Access Compliance Report Public Rights-of-Way (Curb Ramps)

Main Street: N/A Cross Street: BRIOSO_ST Location: E

ADA ID: RPRK211123113750 Ramp Type: Type 7 - Directional 2 Initial Pass/Fail: Fail Overall Compliance: No Severity Score: 30

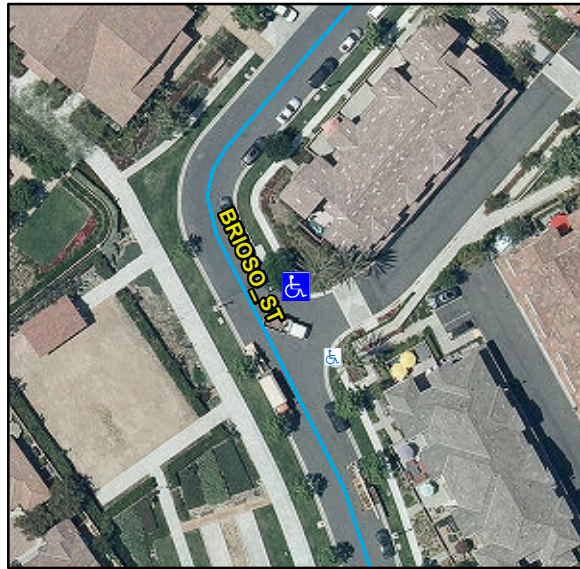
Compliance	Description	Data	Compliance	Description	Data
N/A	Ramp Length (in)	110	N/A	Flare Type LT	
Yes	Ramp Width (in)	48			N/A
No	Ramp Run Slope (%)	12.8	N/A	Flare Slope LT (%)	N/A
Yes	Ramp Cross Slope (%)	0.8	N/A	Flare Traversable LT	N/A
N/A	Grade Break	N/A	N/A	Flare Type RT	
N/A	Grade Break Slope (%)	N/A			N/A
N/A	Grade Break Cross Slope (%)	N/A	N/A	Flare Slope RT (%)	N/A
	Addl Para Ramp Left?	No	N/A	Flare Traversable RT	N/A
	Addl Para Ramp Right?	No	N/A	DWS Provided	N/A
N/A	Landing Present	N/A	N/A	DWS Contrast	N/A
N/A	Landing Length (in)	N/A	N/A	DWS Length (in)	N/A
N/A	Landing Width (in)	N/A	N/A	DWS Full Width	N/A
N/A	Landing Run Slope (%)	N/A		DWS Offset Type	N/A
N/A	Landing Cross Slope (%)	N/A	N/A	DWS Left Offset (in)	N/A
N/A	Landing Movement Obstructed?	N/A	N/A	DWS Right Offset (in)	N/A
	Landing Movement Type	N/A			
N/A	Landing Shared	N/A			
N/A	Marked Crosswalk 1	No	N/A	Clear Space	N/A
	Crossing 1 Direction	S	N/A	Clear Space To Crosswalk (in)	N/A

Marked Crosswalk 1 Width (in)	N/A			
N/A	Ramp Inside Crosswalk 1	N/A			
	Crossing 1 Slope (%)	0.9			
	Crossing 1 Cross Slope (%)	1.4			
N/A	Gutter Ponding	N/A	N/A	Curb Slope	6.3
Yes	Gutter Lip Height (in)	0		Road Run Slope (%)	N/A
N/A	Gutter Run Slope (%)	N/A		Road Cross Slope (%)	N/A
N/A	Gutter Cross Slope (%)	N/A		Parallel Ramp Side	Right
Yes	Overall Surface Condition	Acceptable	Yes	Perp Joint Present	Yes
	Cross Gutter Present?	No		Spandrel Present?	No
	Replace Cross Gutter?	N/A		Replace Spandrel?	N/A

Remove & Replace Entire Ramp.

R304.2.2, STD 1115
